Project
Residence for Mr. ROOPESH

CRN
 CRN-154367-R1-B

Drawing Title
 GROUND FLOOR PLAN

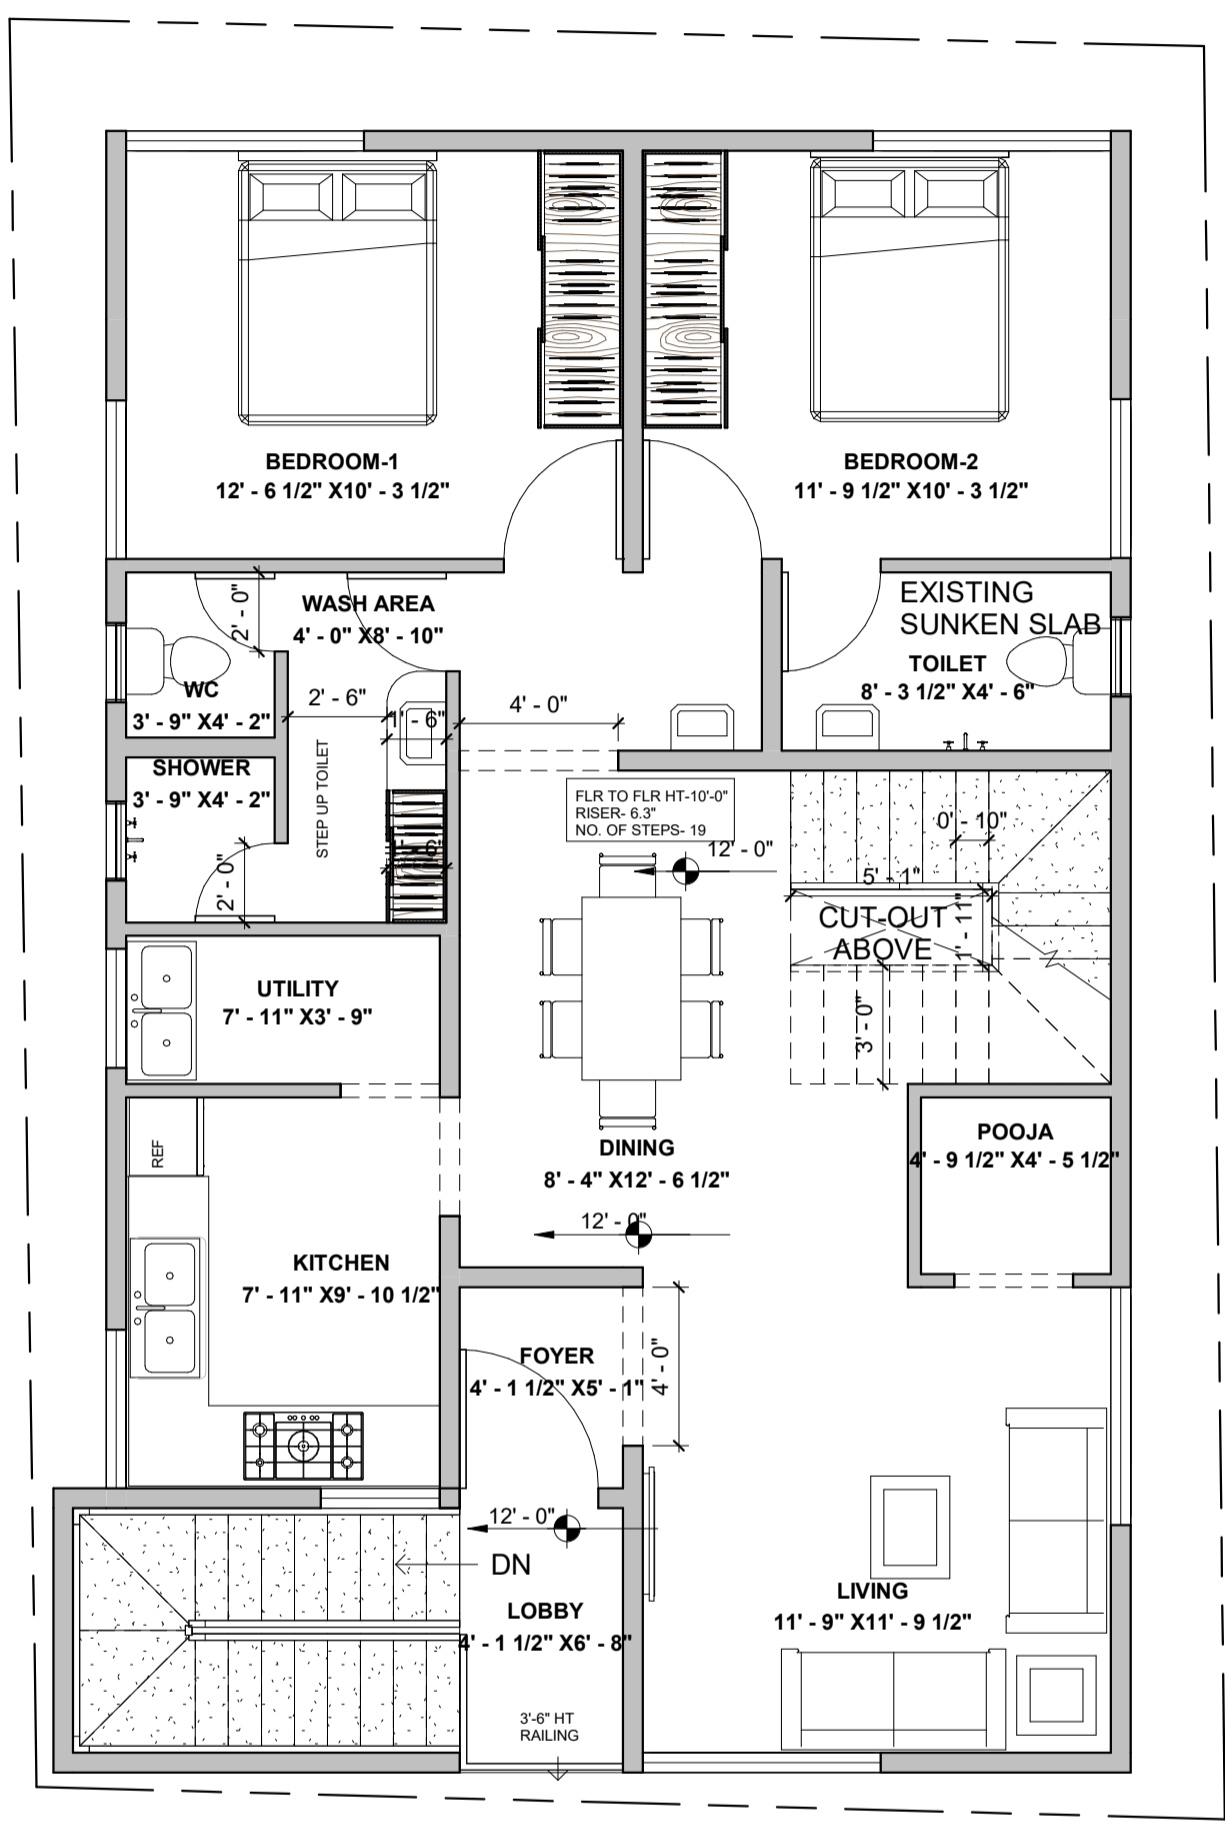
REVISION- R1

1. REMOVE BALCONIES FROM ALL ROOMS

REVISION- R2

1. STAIRCASE ALIGNMENT CHANGED
2. LIVING/POOJA/KITCHEN/INTERNAL STAIRCASE ORIENTATION CHANGED

REVISION- R1-A

1. EXTERNAL STAIRCASE WALL ADDITION
2. FF- POOJA ENTRANCE CHANGED
3. FF- COMMON TOILET LAYOUT CHANGED
4. SF- BEDROOM-3 REMOVED
4. SF- COMMON TOILET LAYOUT CHANGED

REVISION- R1-B

1. EXTERNAL STAIRCASE WALL ALONG WITH STEPS
2. COMMON TOILET- VENTILATION
3. KITCHEN WINDOW- TOWARDS EAST
4. BEDROOM-2 WINDOW POSITION CHANGED-FF

Drawing Title
FIRST FLOOR PLAN

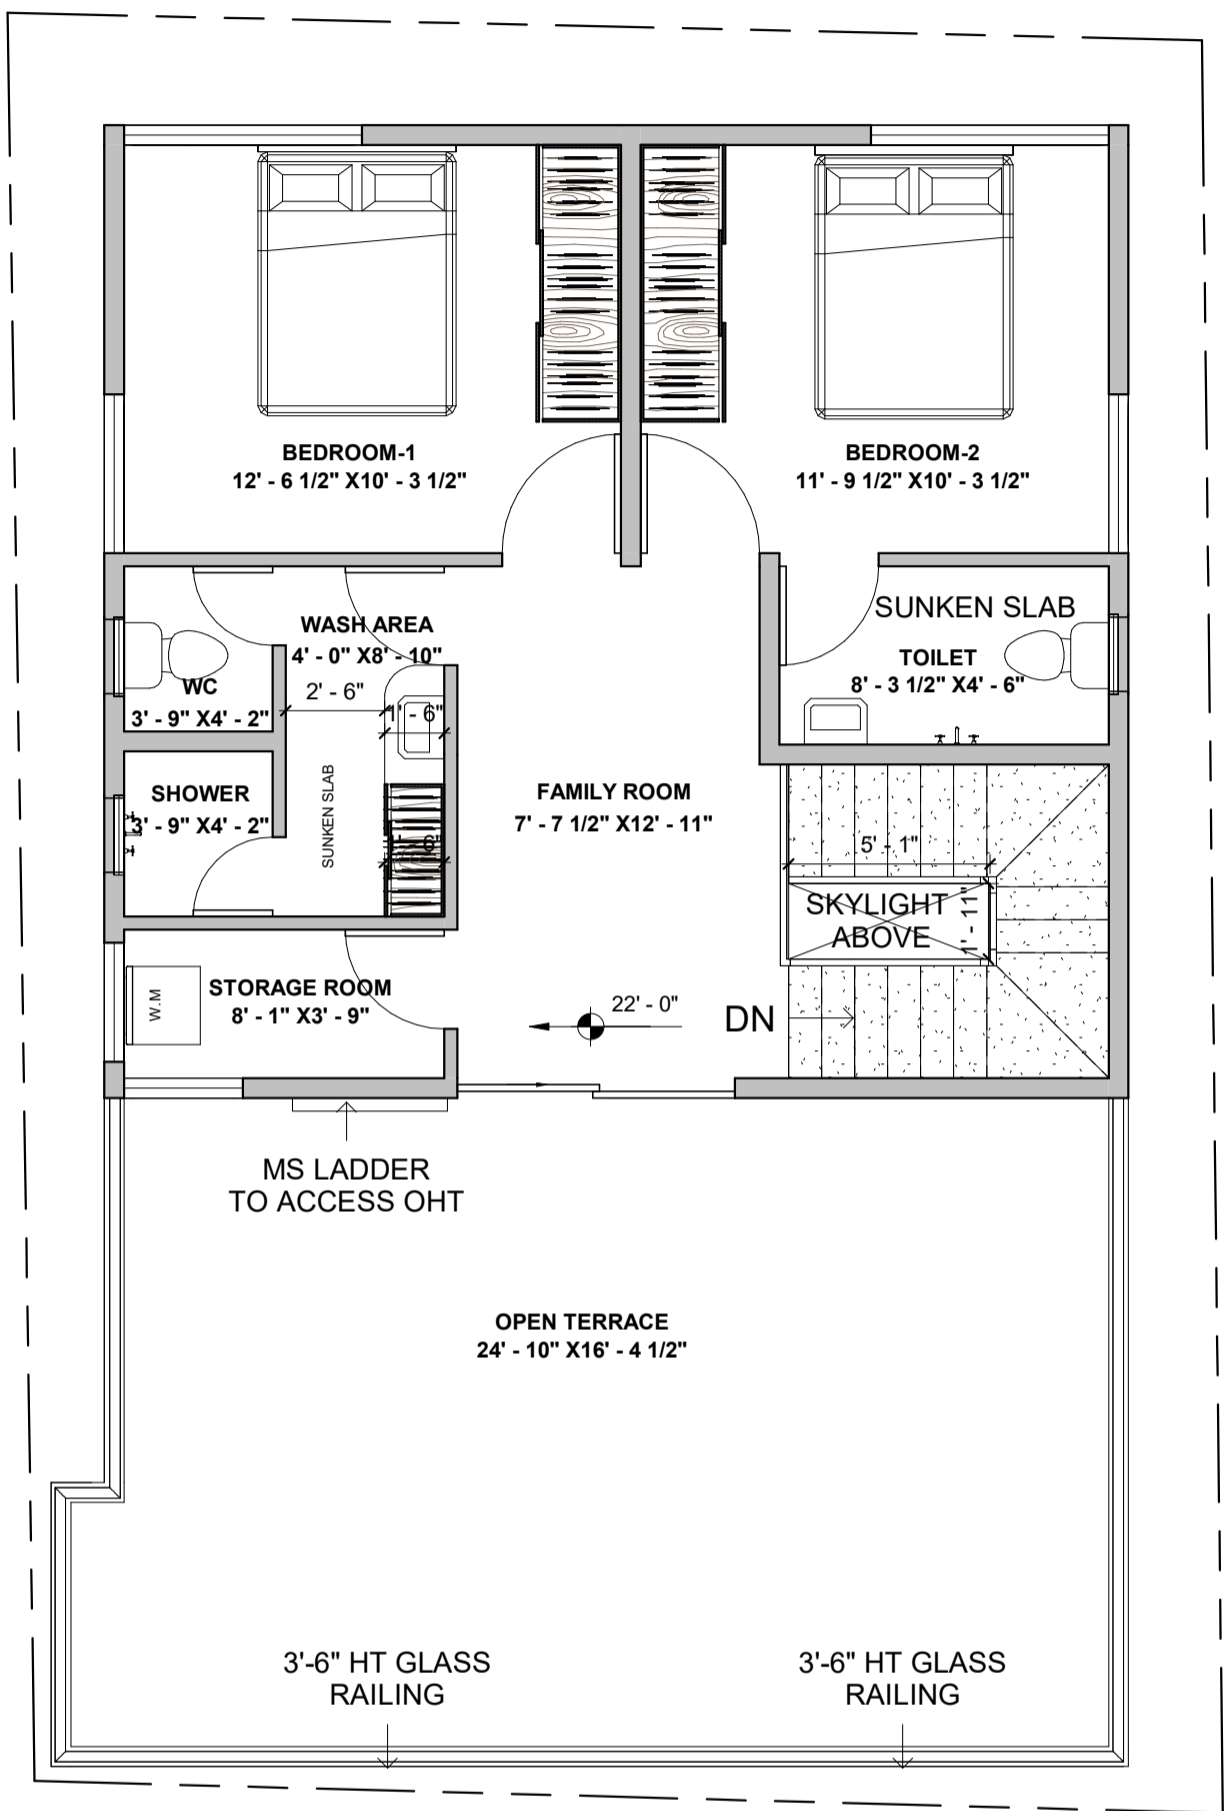
REVISION- R1

1. REMOVE BALCONIES FROM ALL ROOMS

REVISION- R2

1. STAIRCASE ALIGNMENT CHANGED
2. LIVING/POOJA/KITCHEN/INTERNAL STAIRCASE ORIENTATION CHANGED

REVISION- R1-A

1. EXTERNAL STAIRCASE WALL ADDITION
2. FF- POOJA ENTRANCE CHANGED
3. FF- COMMON TOILET LAYOUT CHANGED
4. SF- BEDROOM-3 REMOVED
4. SF- COMMON TOILET LAYOUT CHANGED

REVISION- R1-B

1. EXTERNAL STAIRCASE WALL ALONG WITH STEPS
2. COMMON TOILET- VENTILATION
3. KITCHEN WINDOW- TOWARDS EAST
4. BEDROOM-2 WINDOW POSITION CHANGED-FF

Drawing Title
SECOND FLOOR PLAN

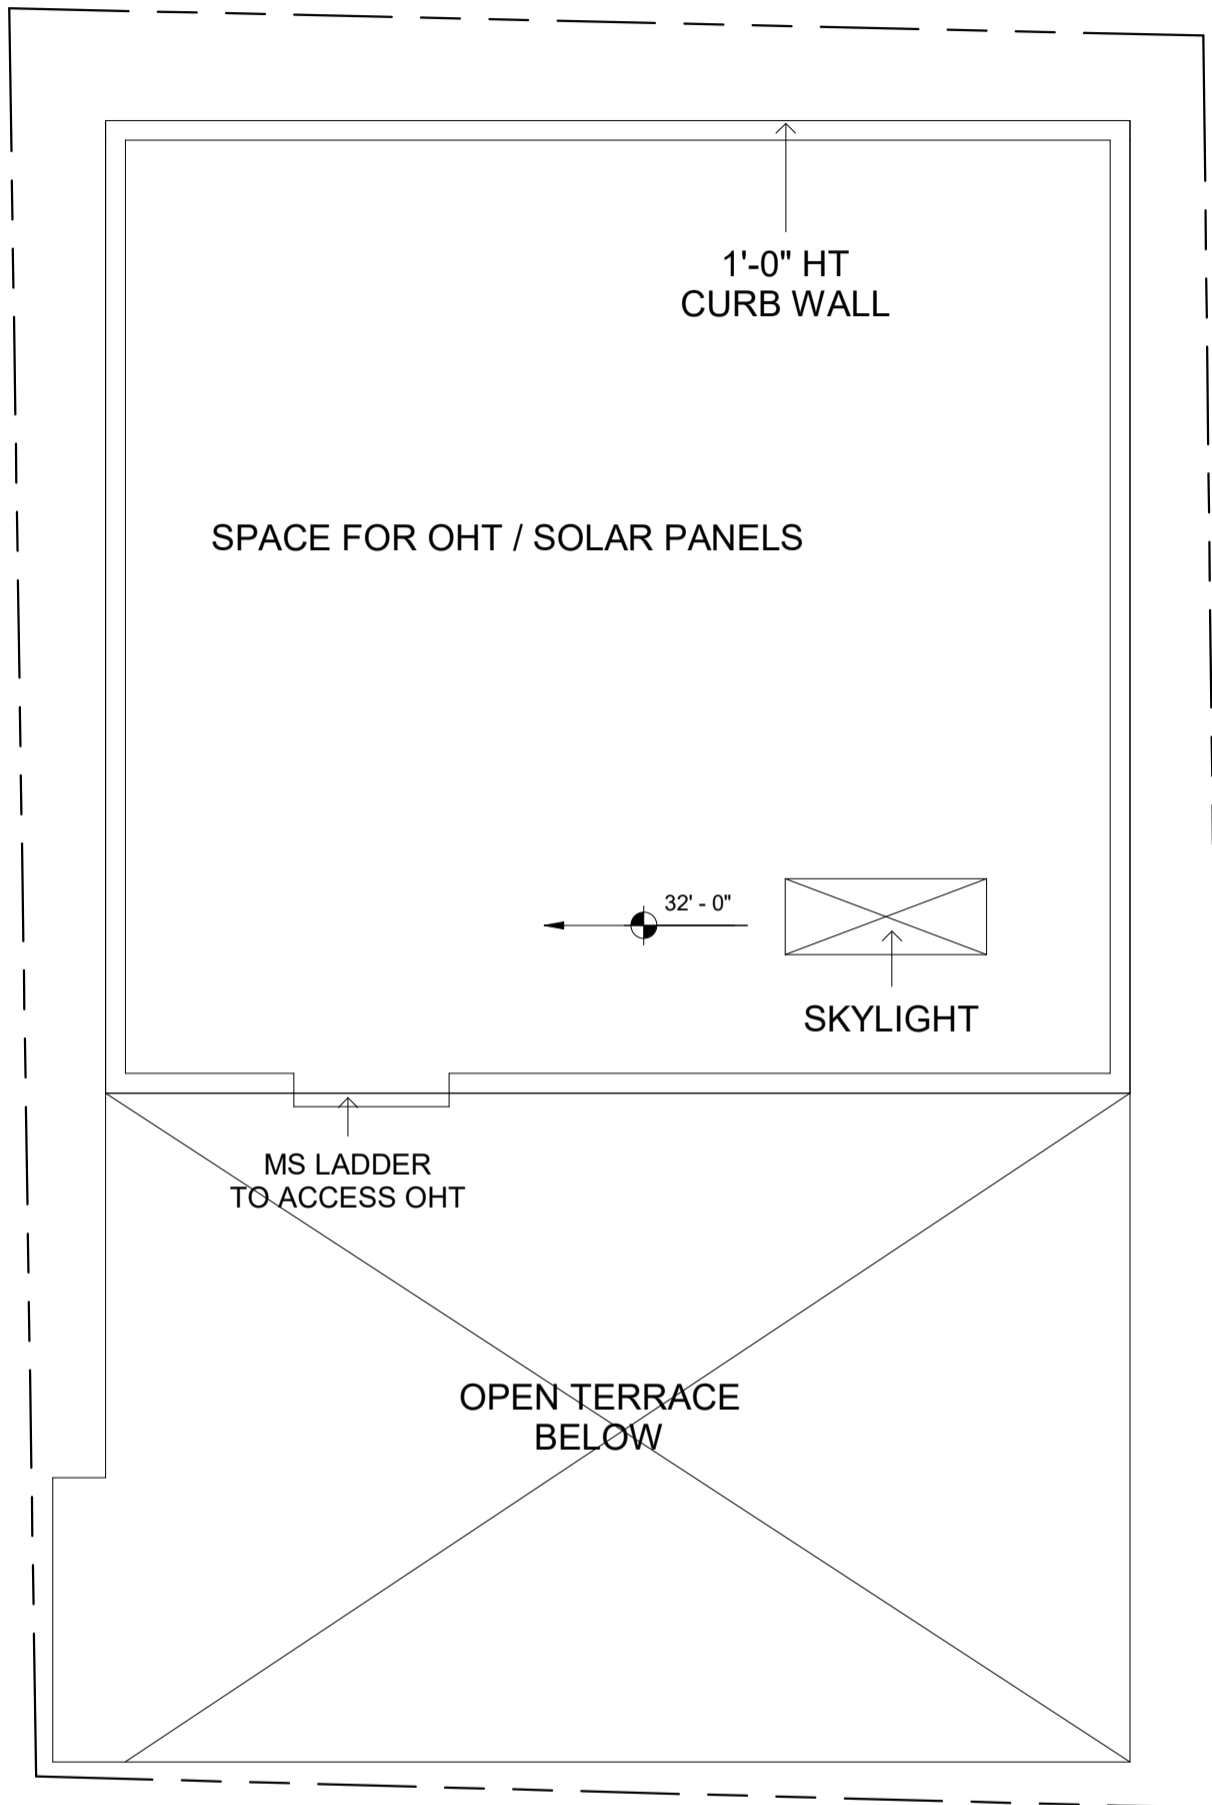
REVISION- R1

1. REMOVE BALCONIES FROM ALL ROOMS

REVISION- R2

1. STAIRCASE ALIGNMENT CHANGED
2. LIVING/POOJA/KITCHEN/INTERNAL STAIRCASE ORIENTATION CHANGED

REVISION- R1-A

1. EXTERNAL STAIRCASE WALL ADDITION
2. FF- POOJA ENTRANCE CHANGED
3. FF- COMMON TOILET LAYOUT CHANGED
4. SF- BEDROOM-3 REMOVED
4. SF- COMMON TOILET LAYOUT CHANGED

REVISION- R1-B

1. EXTERNAL STAIRCASE WALL ALONG WITH STEPS
2. COMMON TOILET- VENTILATION
3. KITCHEN WINDOW- TOWARDS EAST
4. BEDROOM-2 WINDOW POSITION CHANGED-FF
